SUMMARY OF CONCERNS IN RELATION TO THE PROPOSED NORTHCONNEX TUNNEL

This is an objection to many aspects of the proposed NorthConnex tunnel.

MOTORWAY OPERATIONS COMPLEX - SOUTHERN VENTILATION FACILITY - SECTIONS
M1-M2-5000-DR-JD-0525

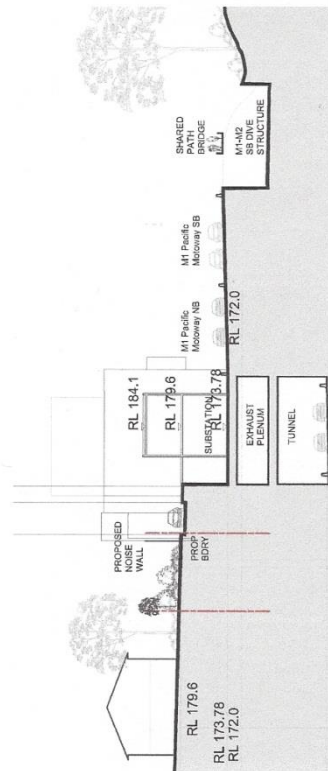
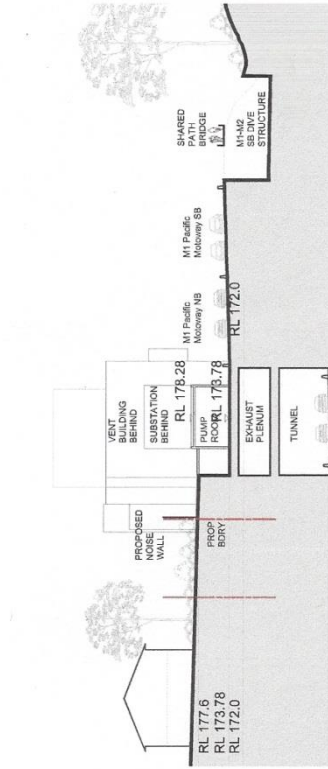
5. *EIS Volume 4, Technical working papers - Urban Design, 6.0 Operational Ancillary Facilities*
EIS Page 99 there is the diagram "Motorway Operations Complex – Southern Ventilation Facility – sections. *Page 10 below* The diagram has the cryptic label "Connection to tunnel TBC". What does TBC stand for? To be considered? Why is tunnel singular? Which tunnel is the diagram referring to northbound or southbound? There is no diagram showing any connection from the Southern Interchange ventilation facility to either the northbound or the southbound tunnel in any way
AND YET

- Diagrams need to be provided showing the inter-relation between the shaft, the ventilation outlet and the motorway operations centre with a clear description of what is to be constructed and how it will operate.
- The community needs irrefutable evidence that the polluted air from the southbound tunnel exit portals will not be allowed to flow like an invisible sewer through West Pennant Hills, North Rocks, Carlingford and Beecroft.

MOTORWAY OPERATIONS COMPLEX - SOUTHERN VENTILATION FACILITY - SITE SECTION 1-1
M1-M2-5000-DR-UD-0713

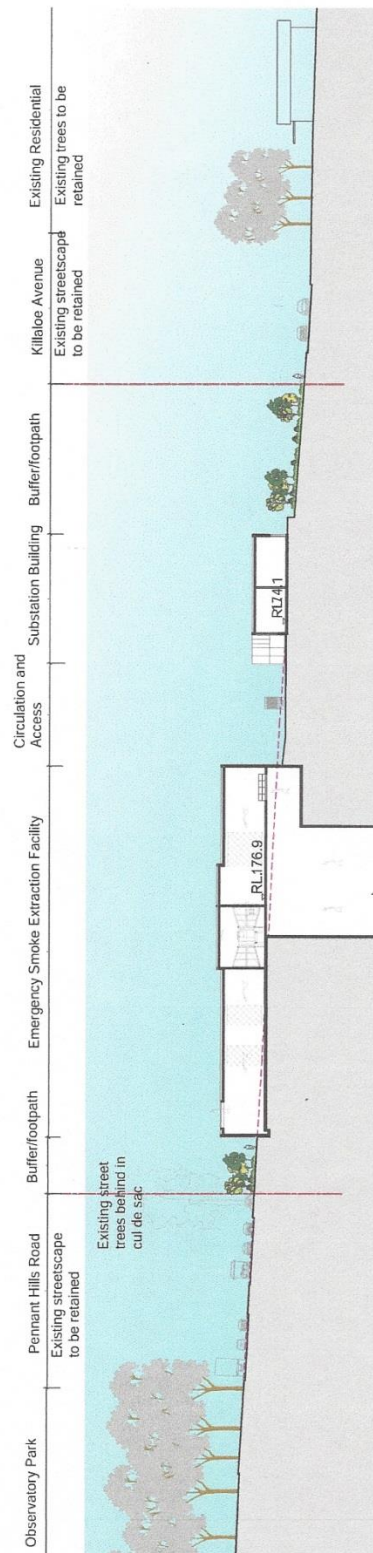
6. *EIS Volume 4, Technical working papers Urban Design, 8.0 Landscape Design*
EIS Page 176 is the diagram "Motorway Operations Complex – Southern Ventilation Facility – Site 1-1". *Page 13 below* The diagram does not show any connection to either the northbound or southbound tunnel. In the same Landscape Design section, EIS Page 182 is the diagram "Wilson Road Tunnel Support Facility –Section" *Page 14 below* which clearly shows the connection to the tunnels. In the same Landscape Design section, EIS Page 189 is the diagram "Northern Ventilation Facility – Landscape Concept Section". *Page 15 below* This also clearly shows the connection to the tunnels.
